Public Works / Finance Committee

5. Residential Street Standard Update Proposal (ACTION ITEM) - Bill Belknap

1. P&Z Request Memo
2. Transportation Commission Minutes 20201008
3. Standard Construction Drawings (revised 2021) pages 1-24
4. Standard Construction Drawings (revised 2021) pages 25-49

Local Street
(28' Street)

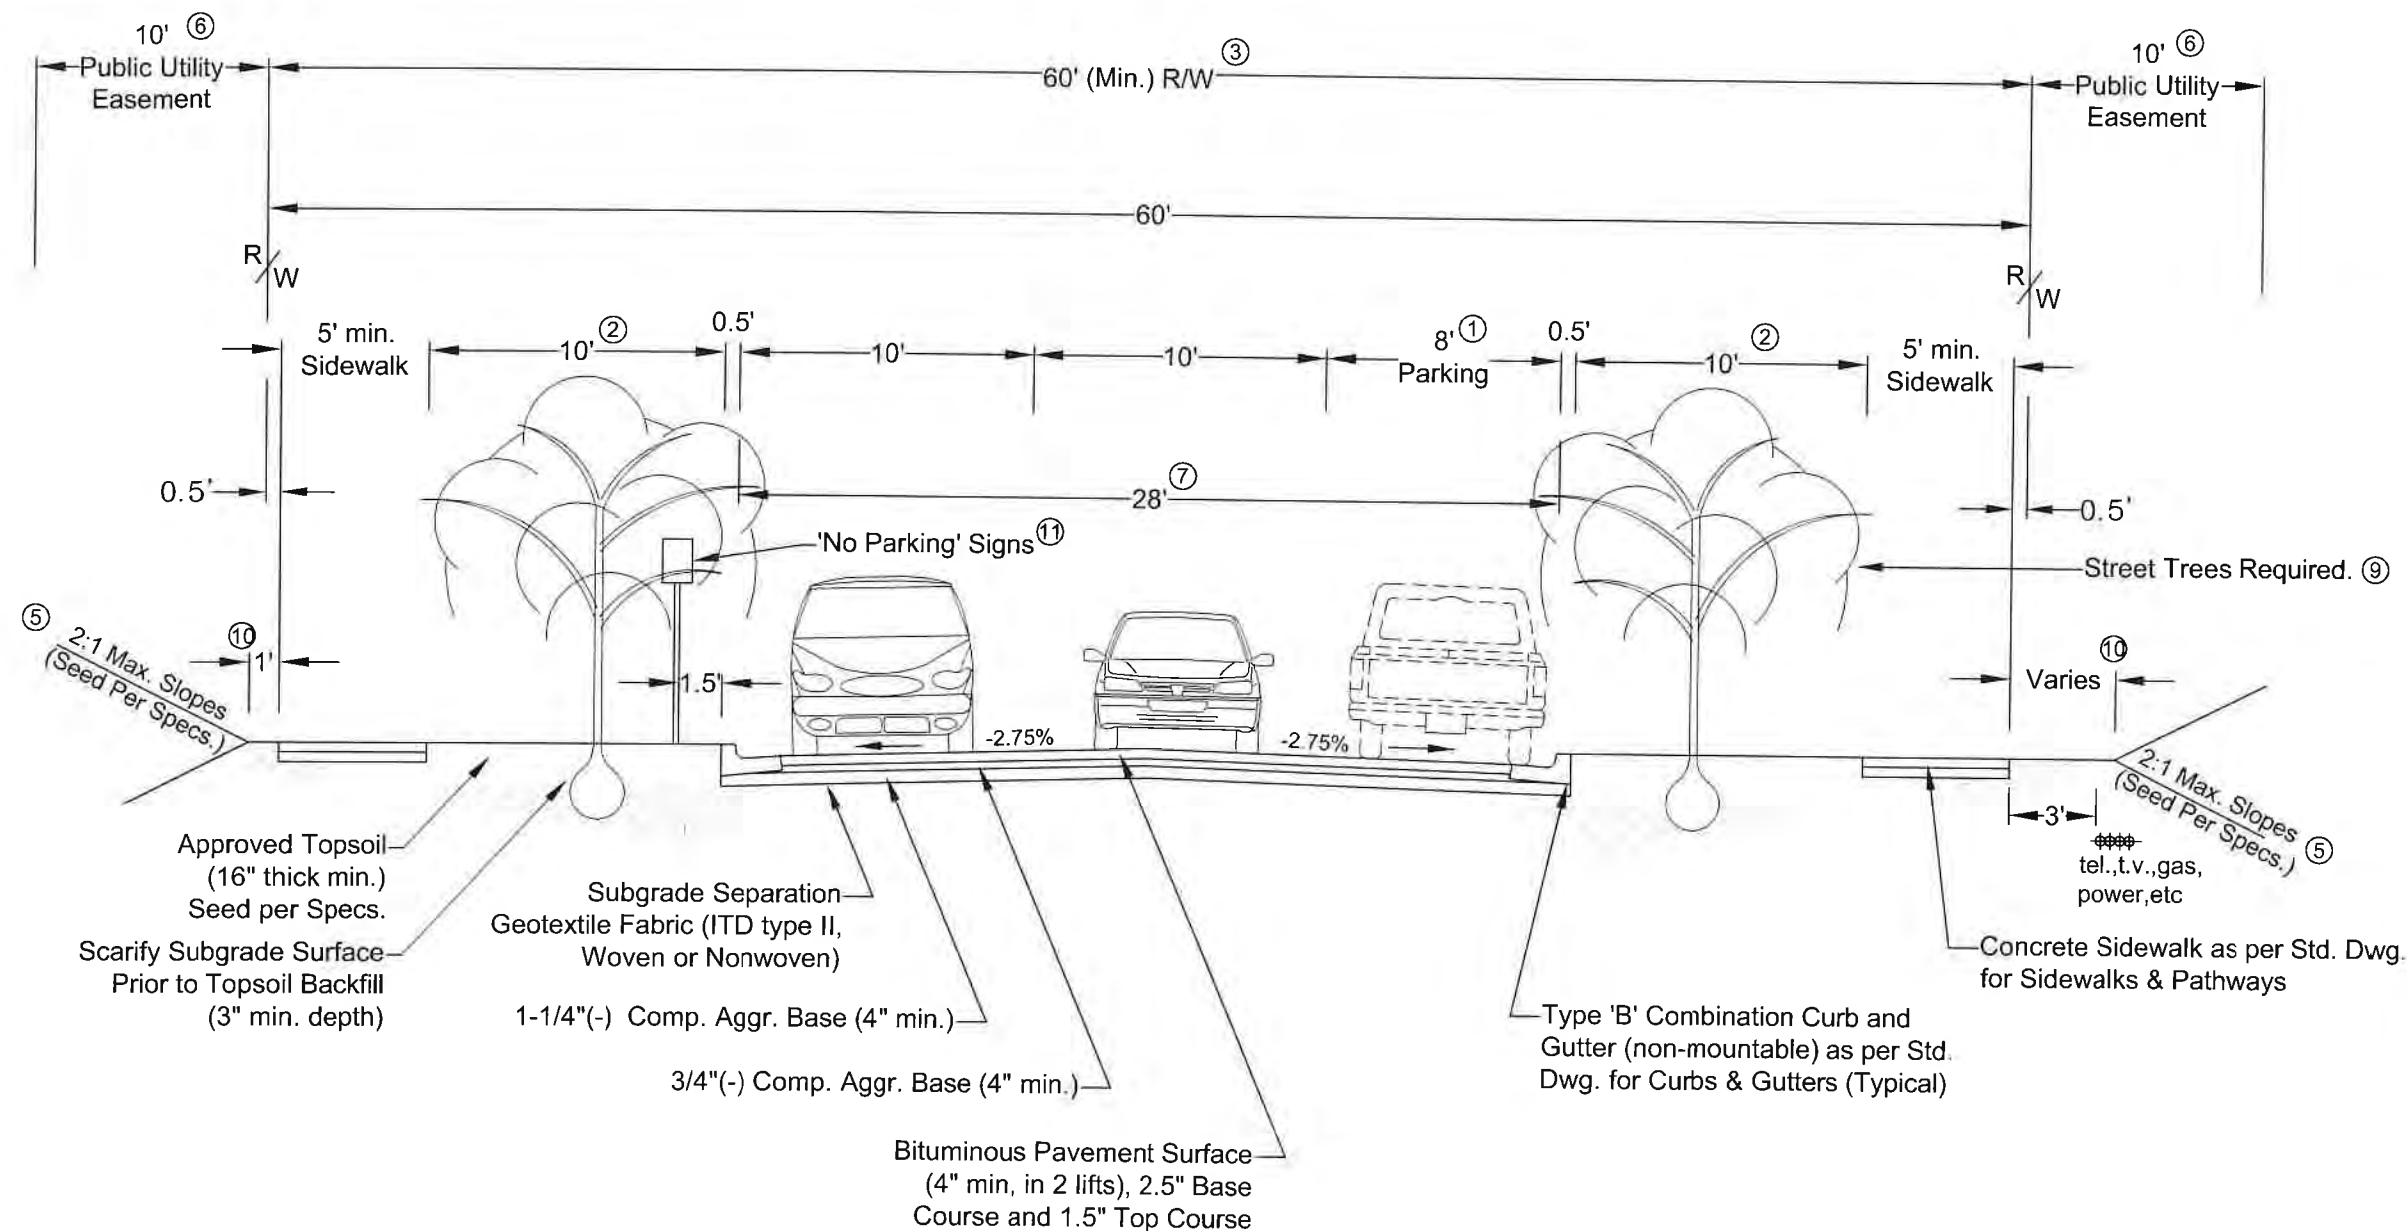
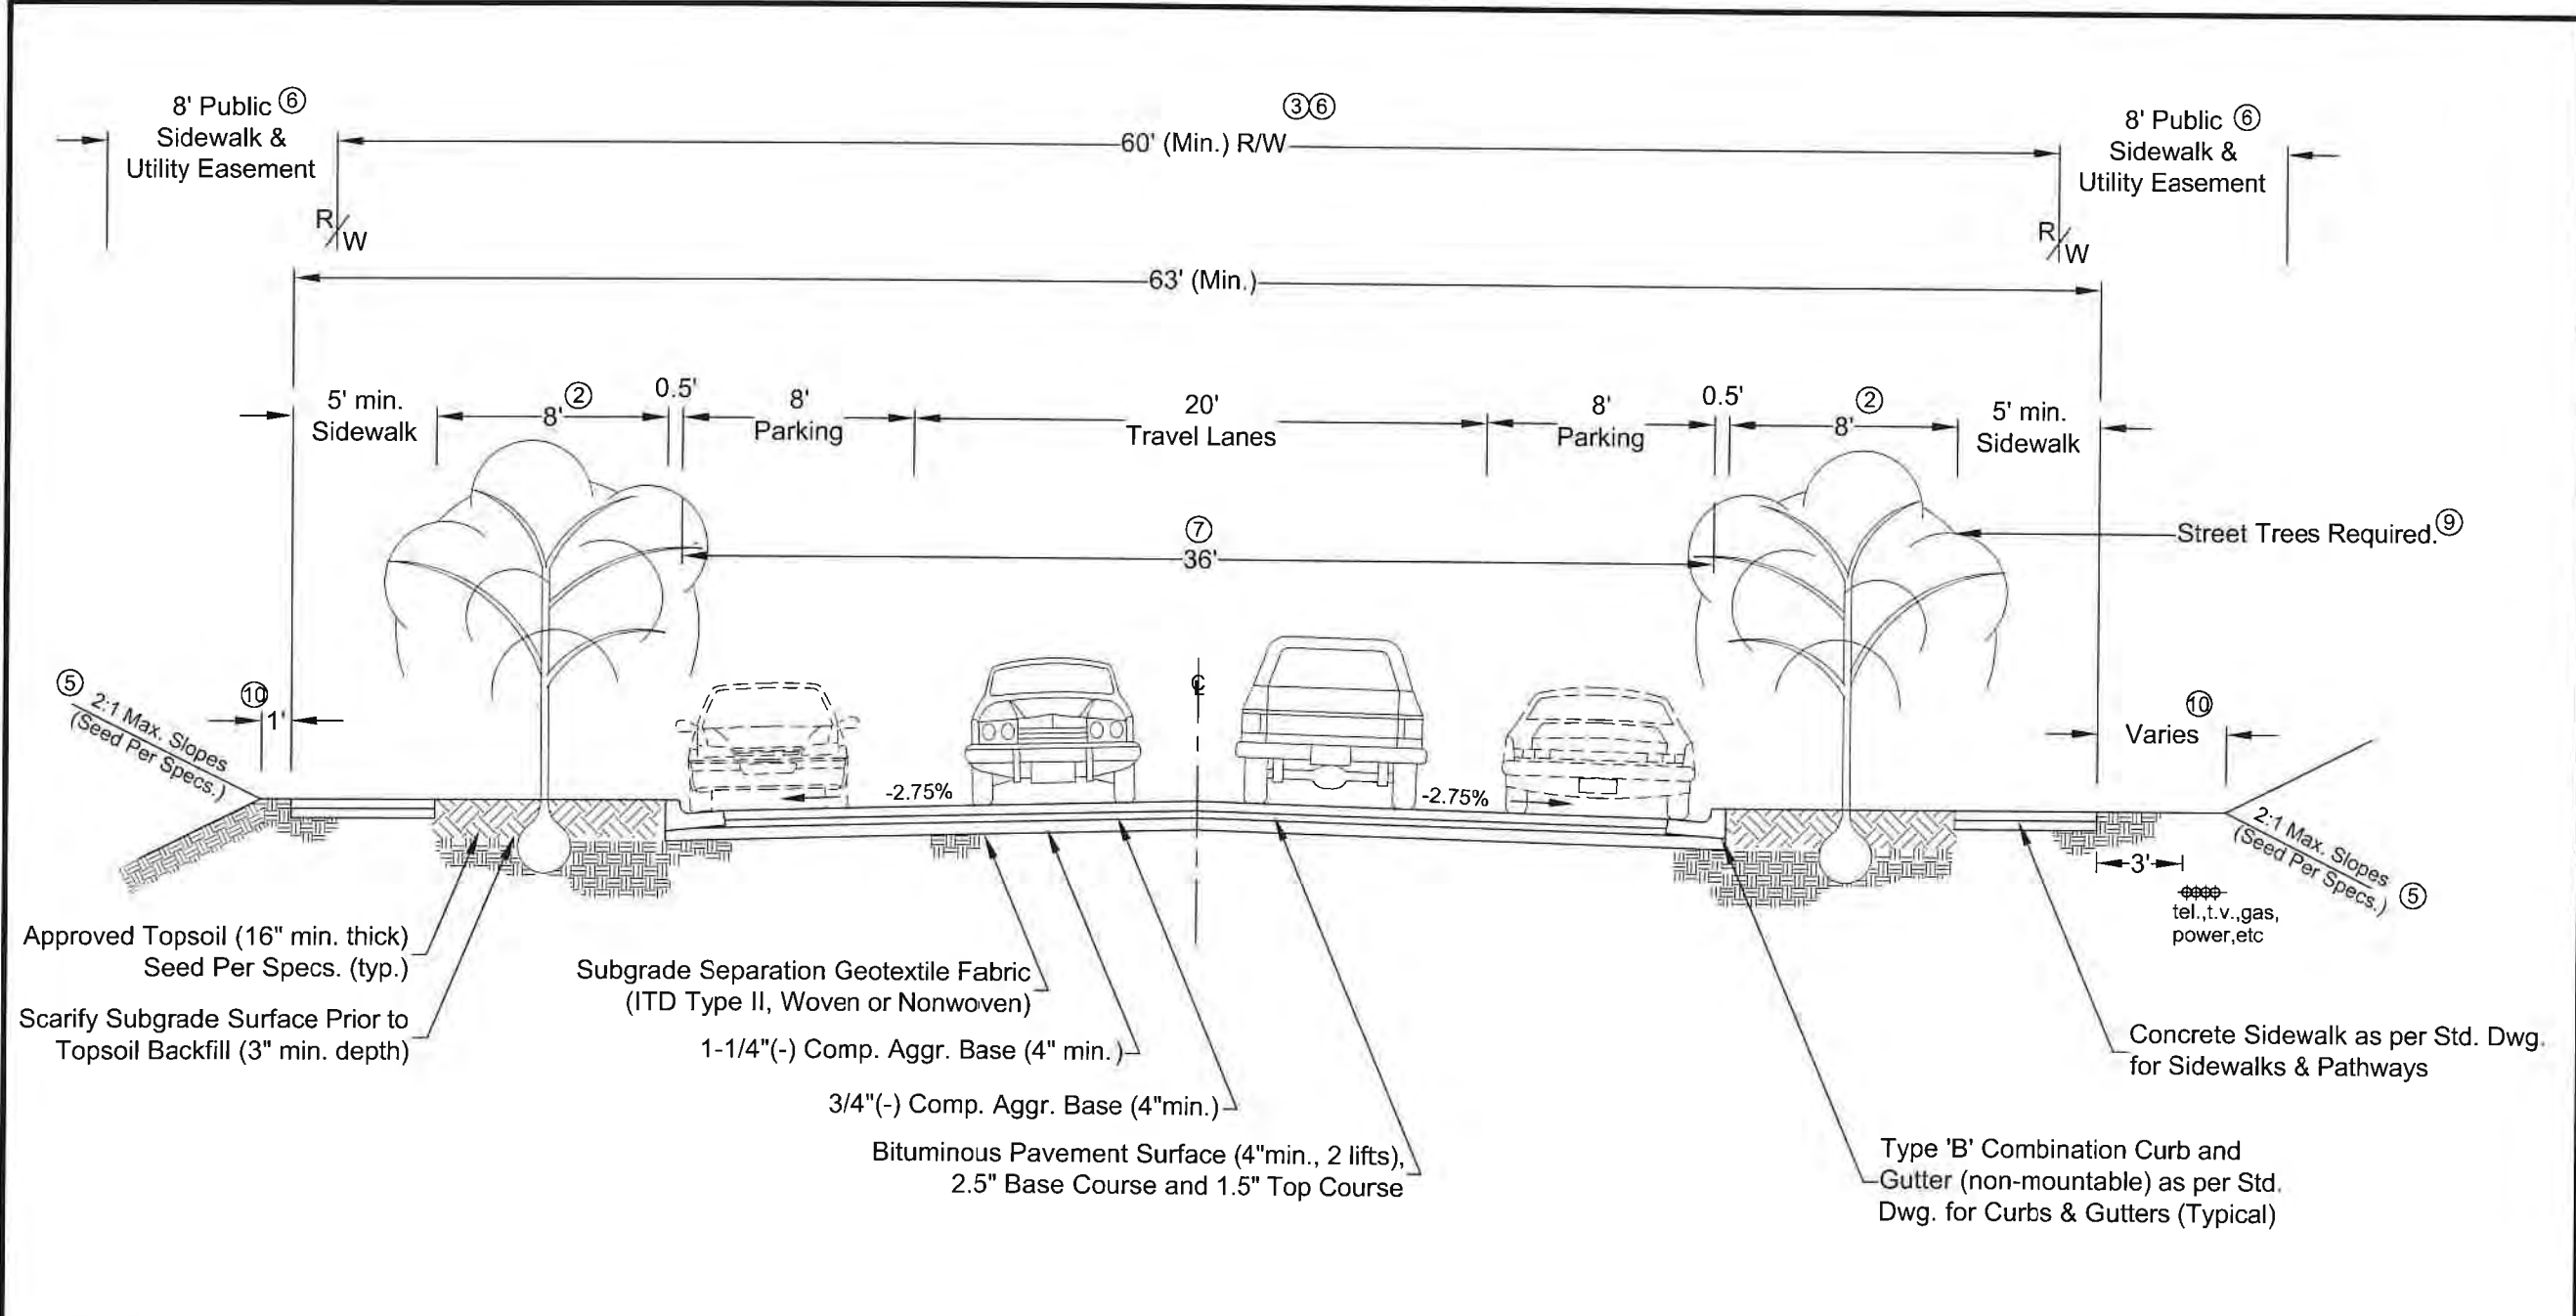
REVISIONS	
DESCRIPTION	DATE
Switched sheets 1a and 1b	2-4-2021
PROFESSIONAL ENGINEER LICENSED 14816 3-2-21 STATE OF IOWA BRIAN SCOTT BONTRAGER	
DRAFTED BY: C. Edwards	CHECKED BY: K. Lilly
DRAWING SCALE: NTS	DATE: 3-31-2014
Alternate Local Street (36' Street)	
CITY OF MOSCOW ENGINEERING DEPARTMENT	
DRAWING NUMBER: 1b

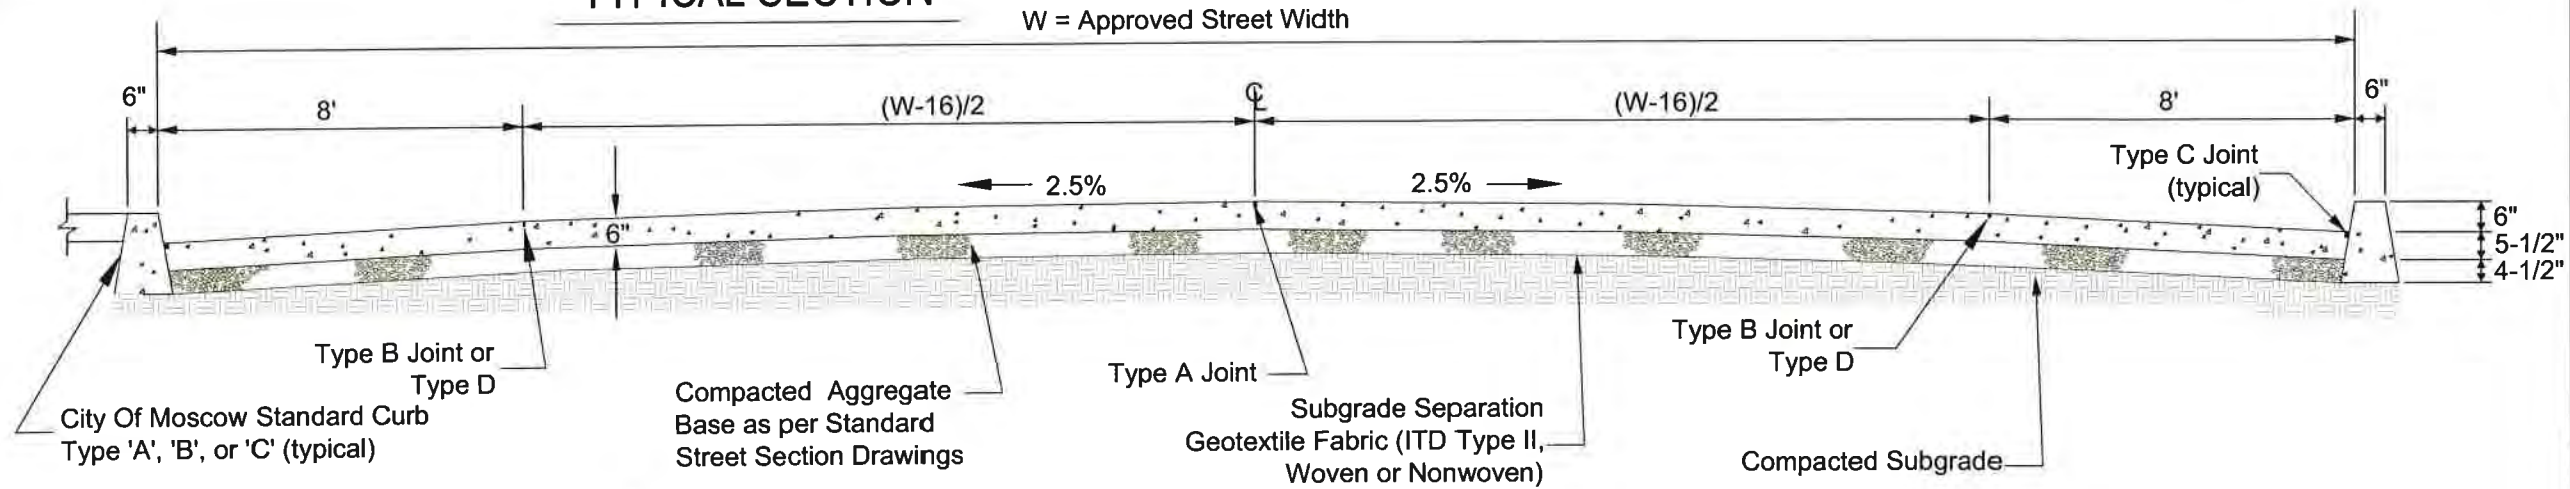
DRIVEWAY APPROACHES CITY OF MOSCOW ENGINEERING DEPARTMENT		DRAFTED BY: K. Kipp / C. Edwards	SIGNED AND DATED PROFESSIONAL ENGINEER LICENSED 14816 2/4/21 STATE OF IDAHO BRIAN SCOTT BONTRAGER		REVISIONS	
		CHECKED BY: K. Lilly			DATE 2-4-2021	DESCRIPTION Changed driveway widths from 20' and 30' to 30' and 40'
		DRAWING SCALE: NOT TO SCALE				
		DATE: 3-5-2014				
DRAWING NUMBER:		9
